Camden Town Hall Annexe

NMA

Crosstree Real Estate Partners LLP

March 2017

Canopy - Approved

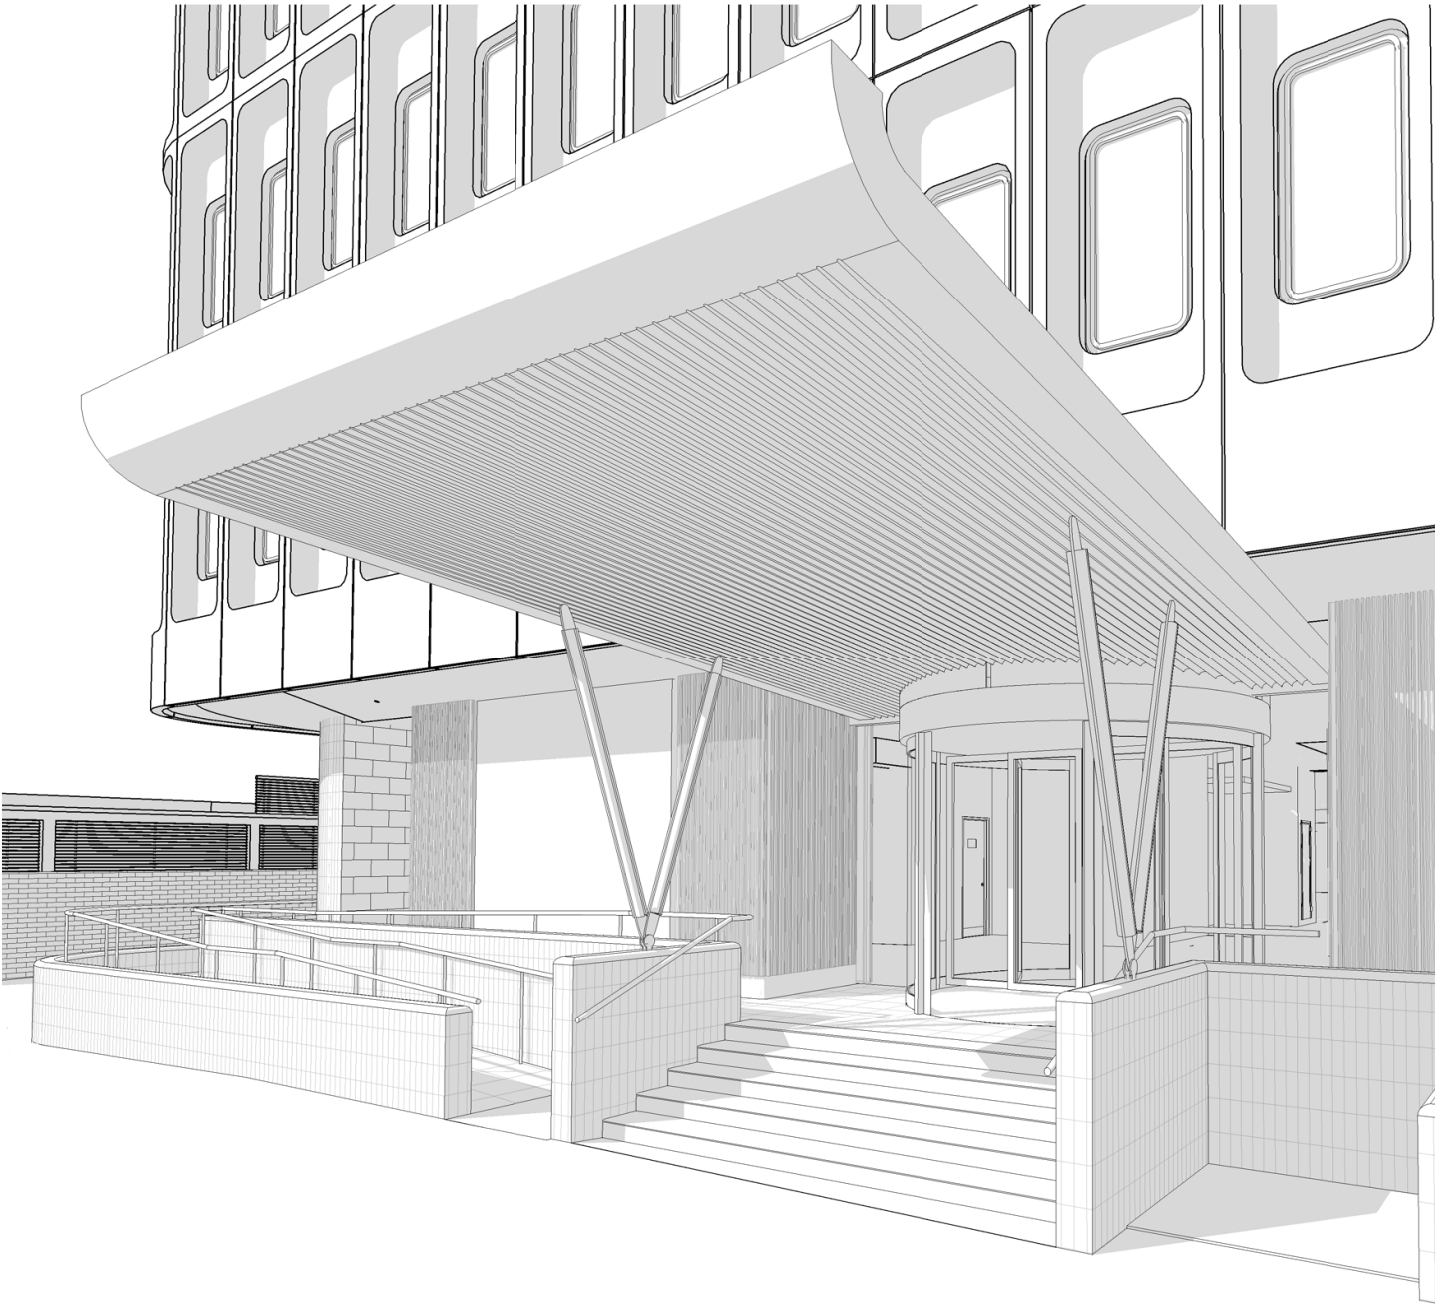
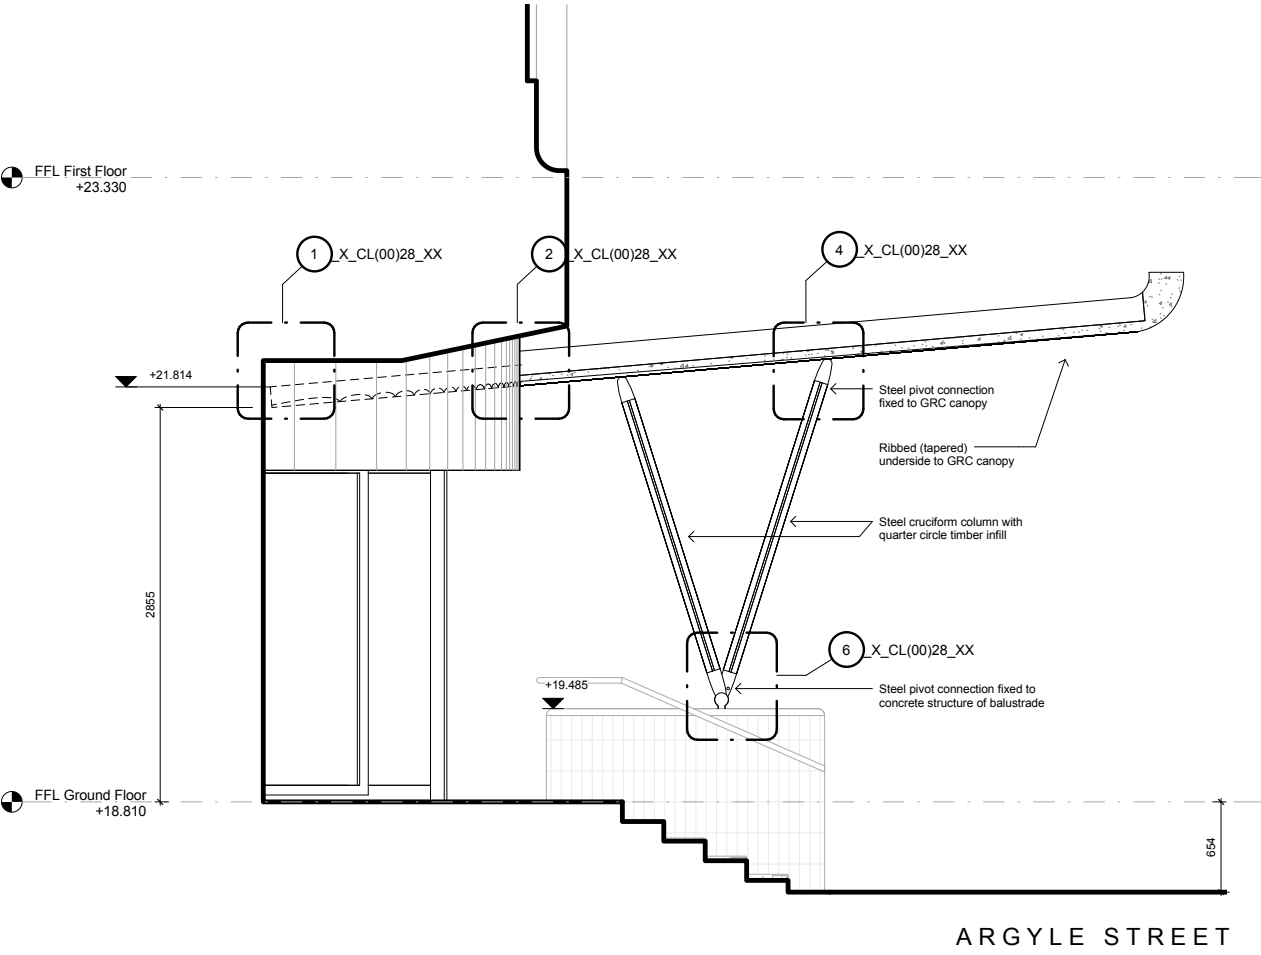
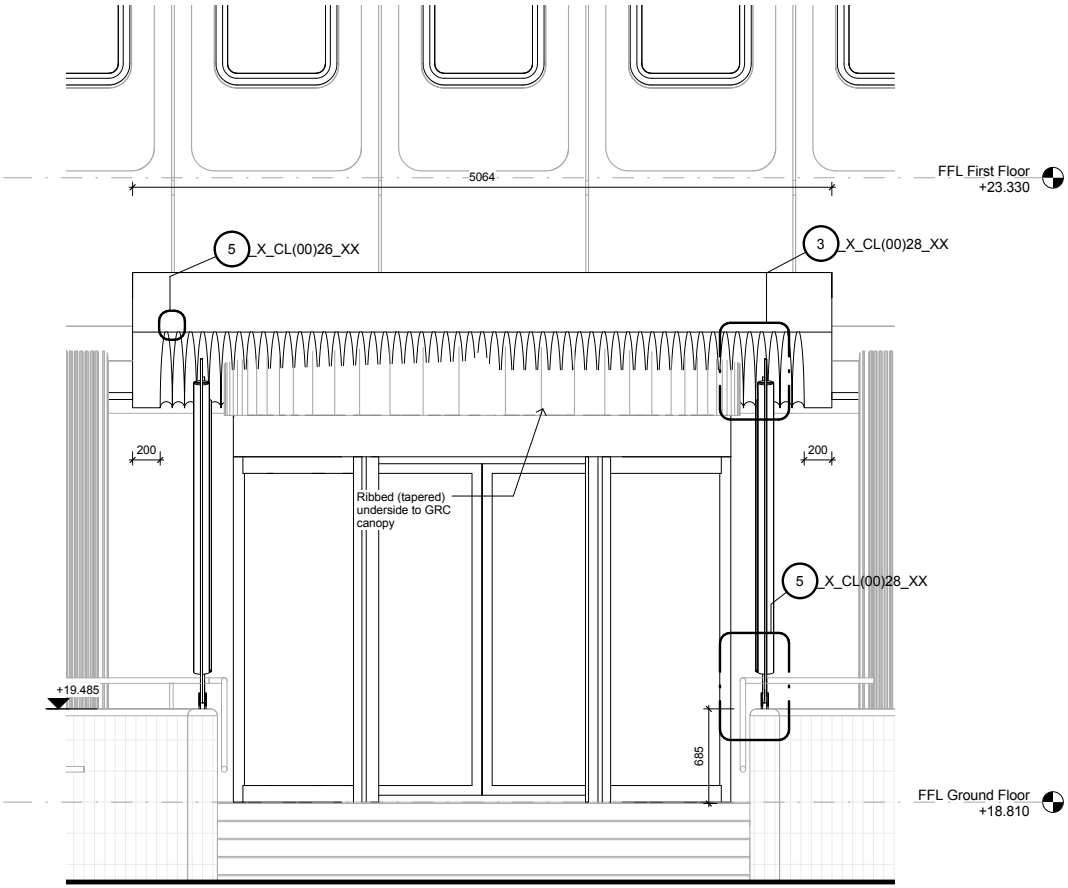
The original metal clad canopy matched the original ground floor facade design. Now that the facade design has been developed, the materiality of the canopy has been revised to suit.

## External Lift

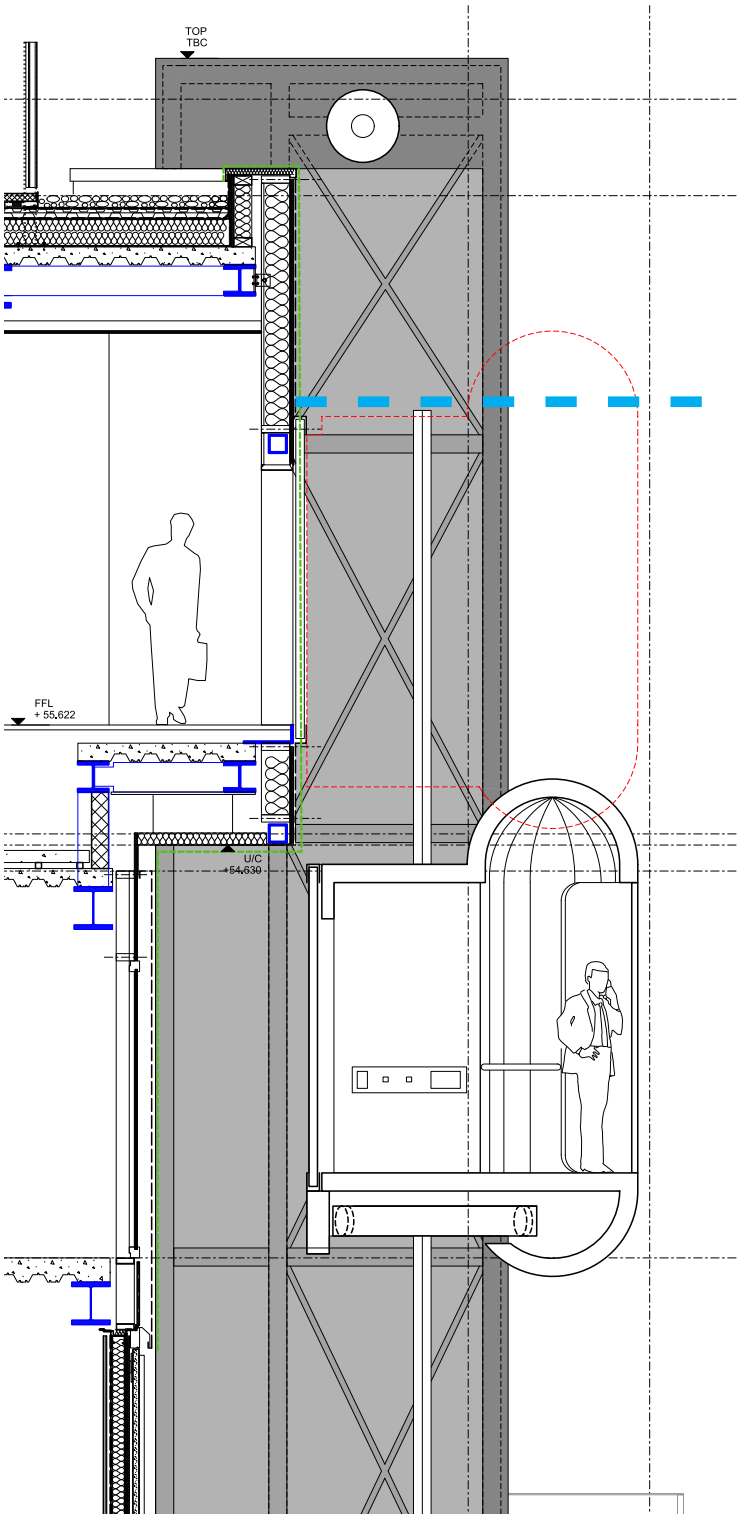
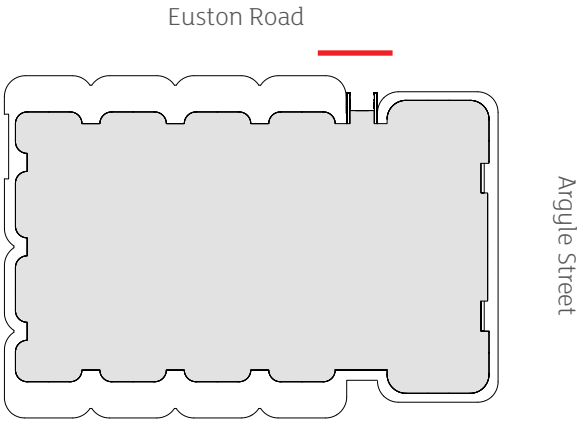
Due to technical requirements of the external lift, the two side 'cheeks' need to extend higher than previously shown. The visual below and section opposite show the new required height.
